response to DRMS TR10 preliminary adequacy review letter for Holcim (US) Inc. Portland, CO Plant

Response to DRMS Technical Revision (TR-10) Preliminary Adequacy Review
Holcim (US) Inc. Portland, Colorado Limestone Quarry, Permit No. M-1977-344

November 19, 2014

Figure 2. Sulfate, Sodium, and Potassium versus Depth to Groundwater

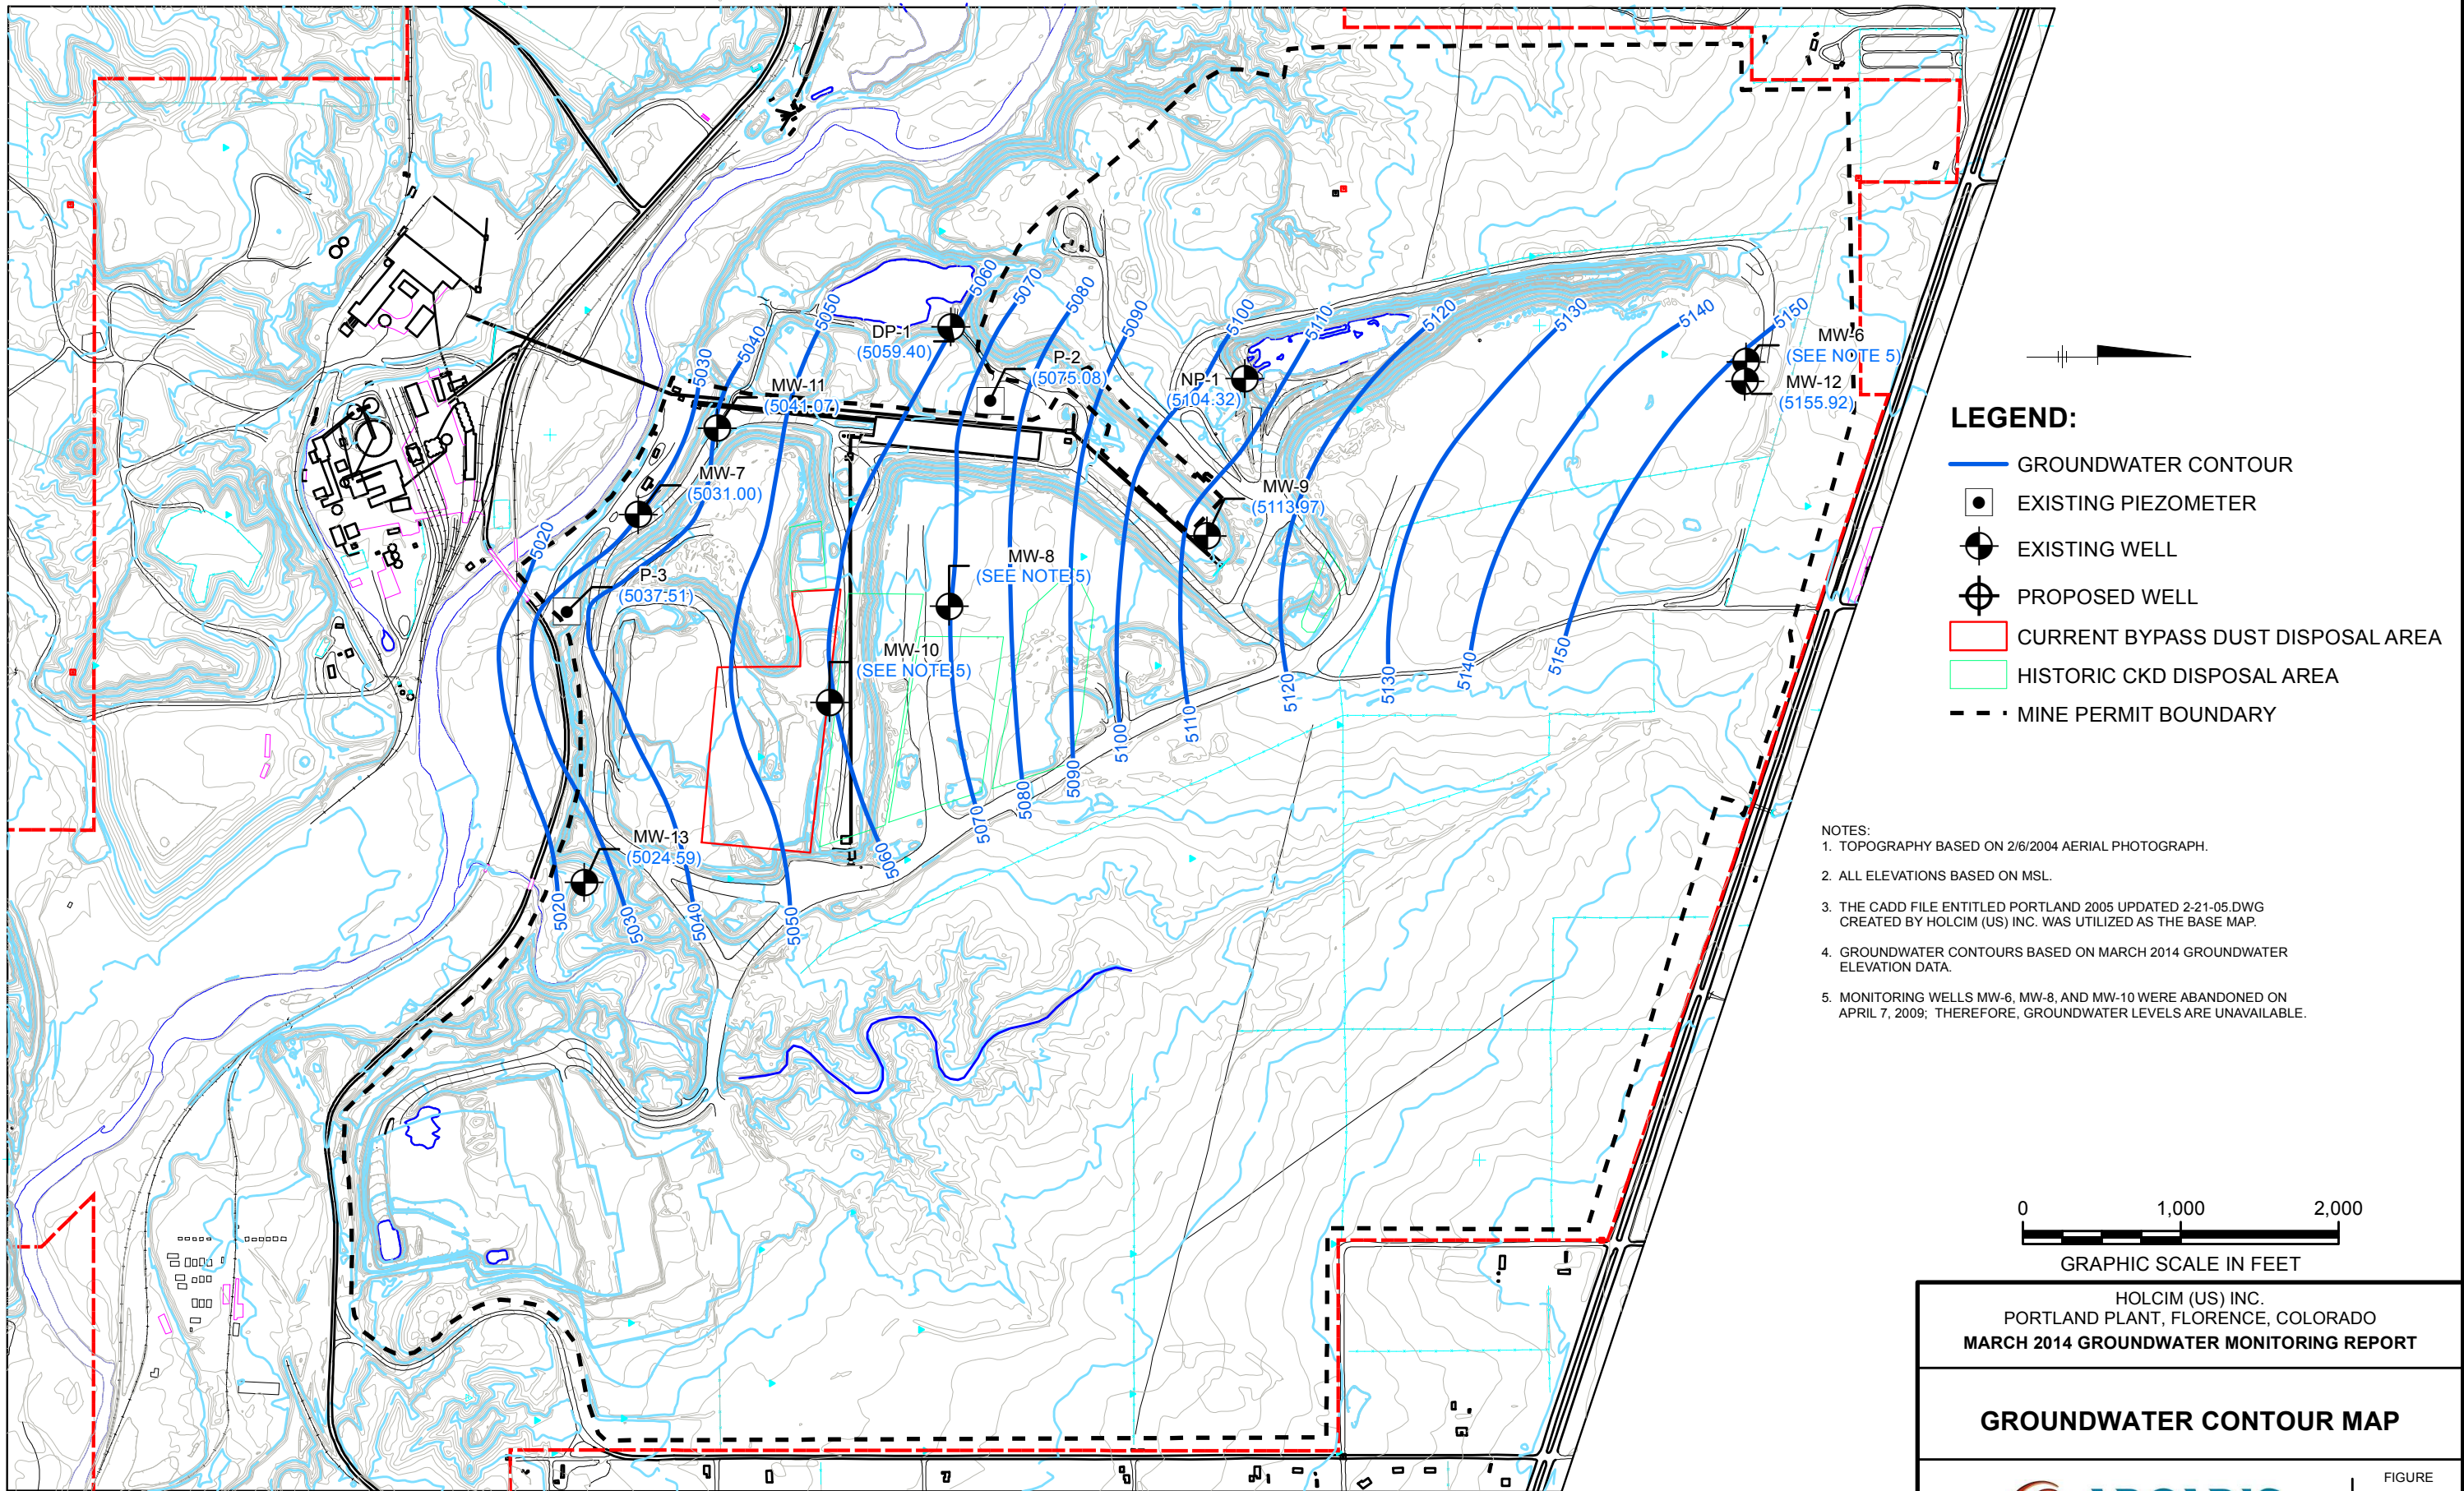
The DRMS acknowledges that the higher concentrations of sodium observed in MW-7 may be partially attributable to lower water levels in that monitoring well, but commented that ARCADIS should provide further discussion as to why the increased sodium concentrations are not attributable to impacts from CKD.

We have further evaluated the effect of depth to water in monitoring well MW-7 (see **Figure 1** for location) to water quality in that well by preparing concentration versus depth to groundwater graphs for sulfate and potassium, two of the other constituents analyzed as part of the Groundwater Monitoring Plan (GMP) for the site. These graphs are presented in **Figure 2** along with a sodium concentration versus depth to groundwater graph. The graphs demonstrate that while sodium concentration increase with increasing depth to groundwater, sulfate and sodium concentrations are inversely related to depth to groundwater. The correlation between and sulfate and potassium concentrations and depth to water is not as strong when compared to sodium after 2010, as indicated by the two observed “spikes” in concentration (**Figure 2**), particularly for sulfate. However, for both potassium and sulfate, when depth to groundwater decreases, constituent concentrations increase. All three constituents are present in the CKD (see **Table 1**), and potassium and sulfate are present in the CKD at much higher concentrations than sodium (see discussion below) and all three constituents are highly leachable.. It follows that if the observed increases in sodium concentrations were associated with the CKD landfill, then corresponding increases in sulfate and potassium should be observed. The historical data for these two constituents do not exhibit this pattern.

- Sodium concentrations increase with increasing depth to groundwater
- Sulfate and potassium concentrations are inversely related to depth to groundwater

Figure 3. Sodium Concentrations versus Potassium to Sodium and Chloride to Sodium Ratios

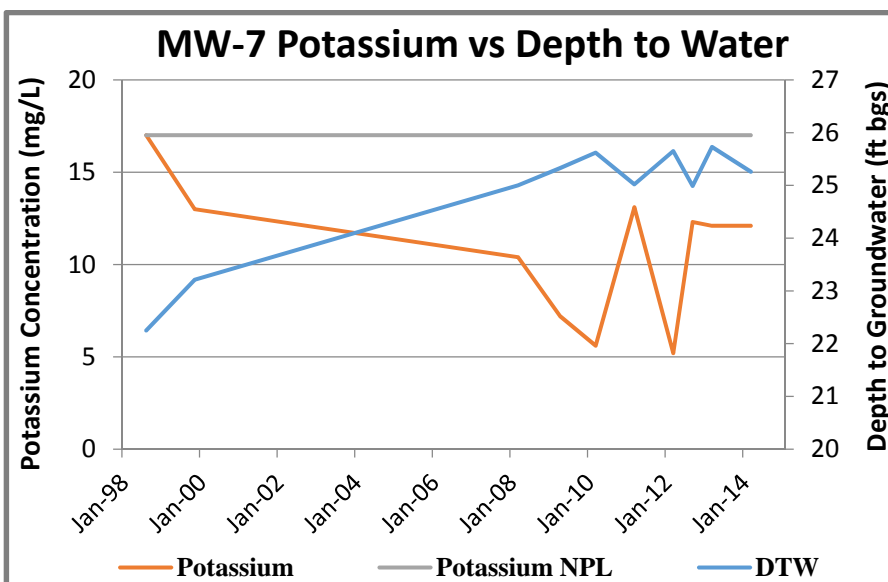
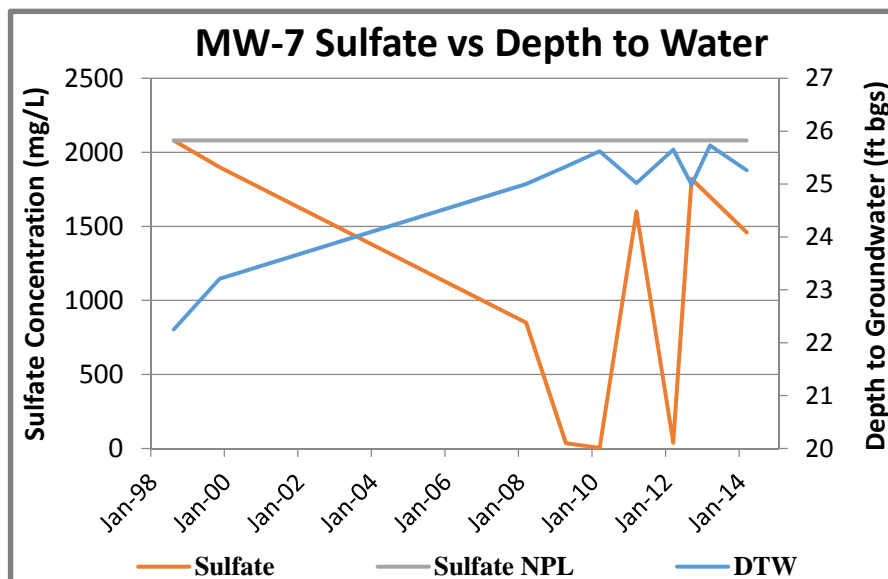
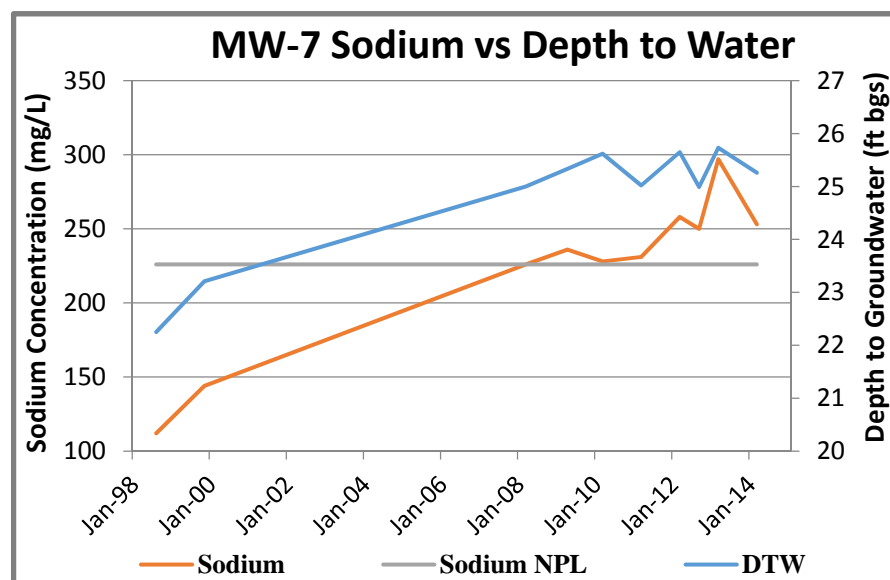
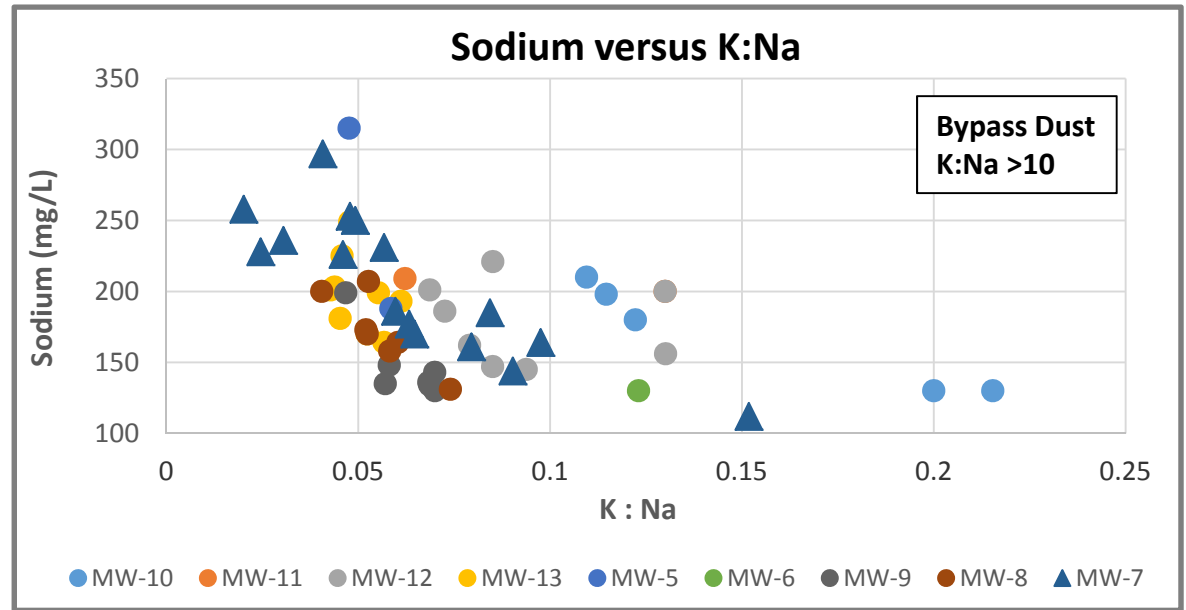
The DRMS has stated: "The 2009-2010 K:Na ratio for reported values are roughly 0.05, an order of magnitude less. Furthermore, if Na concentrations continue to increase, while K concentrations remain essentially the same, the proposed ratio of 0.5 will be quite easy to achieve. Of greater concern is that both Na and K concentrations could increase over time, but as long as the concentration of Na is at least twice that the K, the proposed standard would be met. Significant increases in either Na or K and Na should be viewed as a concern from the Division's viewpoint. A greater discussion on the K:Na chemistry as it relates to CKD and a more compelling argument for the K:Na ratio needs to be provided to the Division before this approach can be considered."

- Bypass Dust K:Na values typically > 10
- Groundwater K:Na values <0.25
- MW-7 K:Na decreases with increasing Na concentration
- MW-7 K:Na values not consistent with Bypass Dust source of Na

- Bypass Dust Cl:Na values typically > 20
- Groundwater K:Na values <0.3
- MW-7 no relation between sodium concentration and Cl:Na
- MW-7 Cl:Na values not consistent with Bypass Dust source of Na

Figure 4. Sodium and Sulfate Concentrations

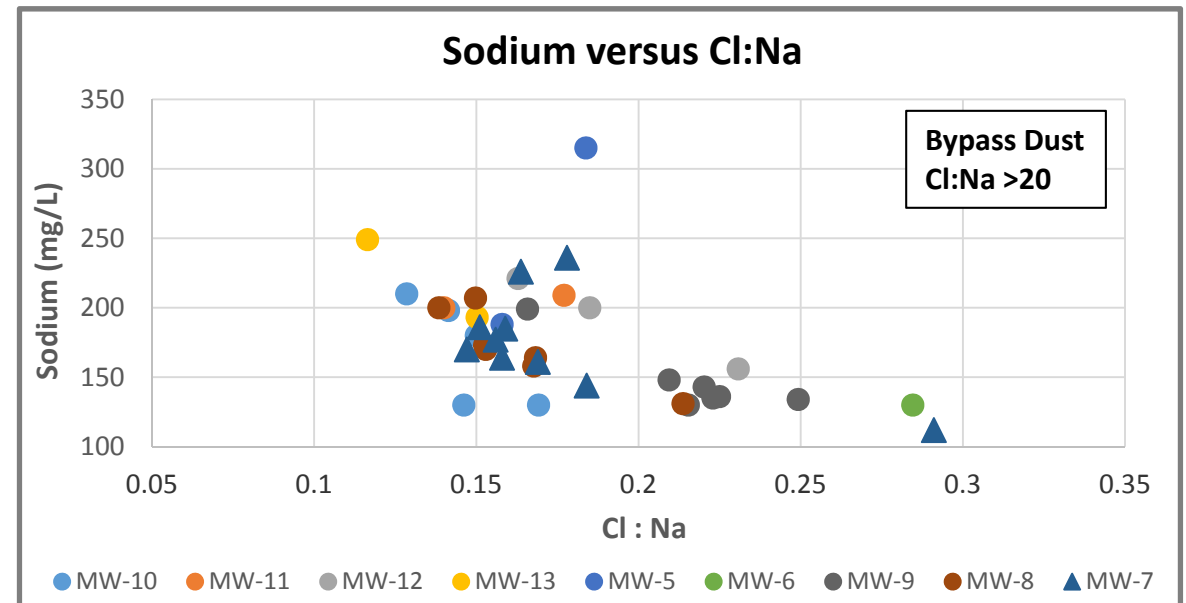
Groundwater data were evaluated further to better understand the potential cause of increasing sodium concentrations at MW-7. **Figure 4** demonstrates little relation between sodium and sulfate concentrations for groundwater monitoring locations with the exception of MW-7, which shows a strong inverse relation between sodium and sulfate concentrations. These results suggest that water with different

- Most groundwater monitoring locations have no relation between sodium and sulfate concentrations
- MW-7 samples exhibit strong inverse relation between sodium and sulfate concentrations

Figure 5. General Geochemistry

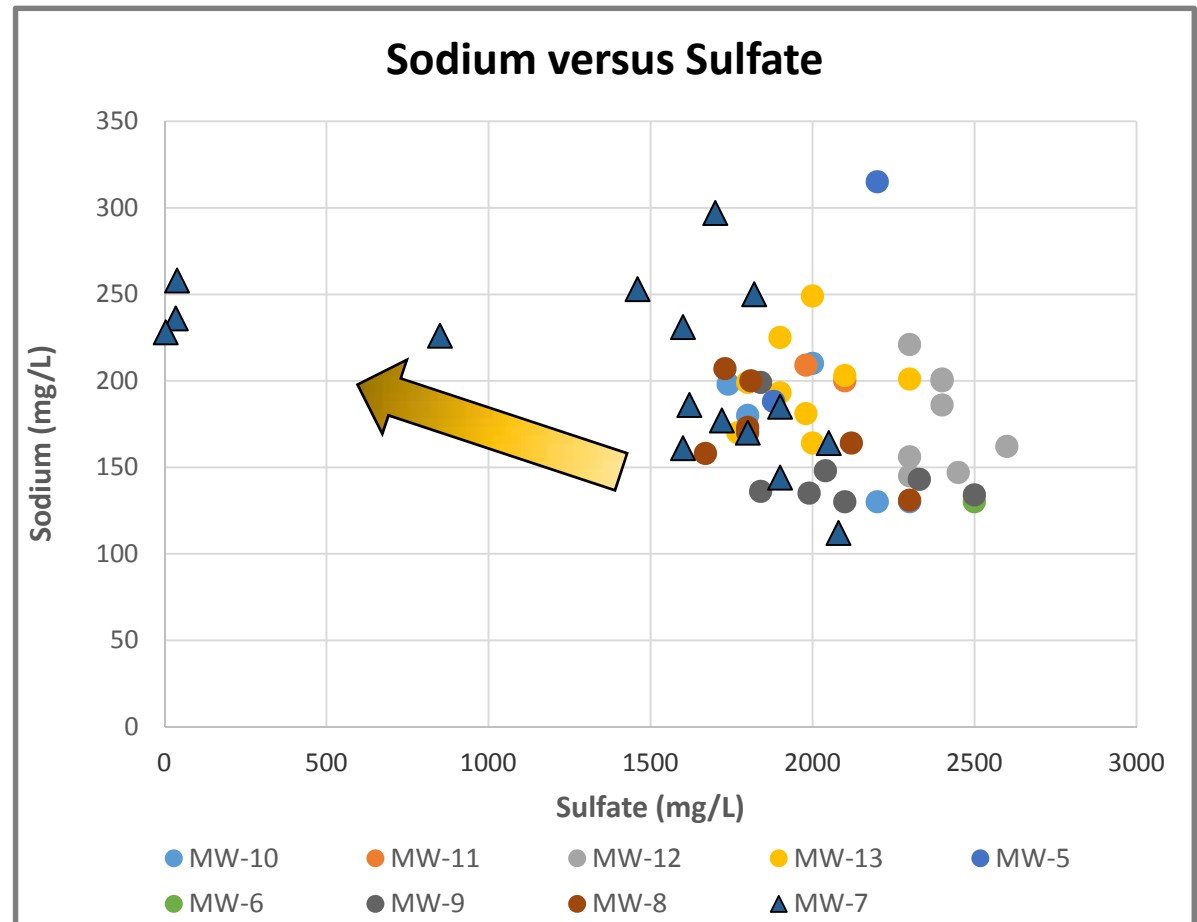
compositional “types” is entering into the MW-7 monitoring well. Trilinear diagrams, also known as Piper diagrams, were developed for select samples that had sufficient data for plotting. As shown in **Figure 5**, most groundwater samples plotted within the calcium plus magnesium, sulfate $[Ca+Mg-SO_4]$ type water field shown in the upper portion of the diamond. However, the MW-7 2008 sample is shifted away from the primary group of samples towards the sodium plus potassium, bicarbonate $[Na+K-HCO_3]$ type water while the MW-7 2009 sample is clearly a $Na+K-HCO_3$ type water. These shifts in water composition occurred when depth to groundwater increased.

- Most samples plot within the Ca, Mg-SO_4 water type
- MW-7 shift to Na-HCO_3 type water with increasing depth to water
- Contributions of water to MW-7 from different geologic strata
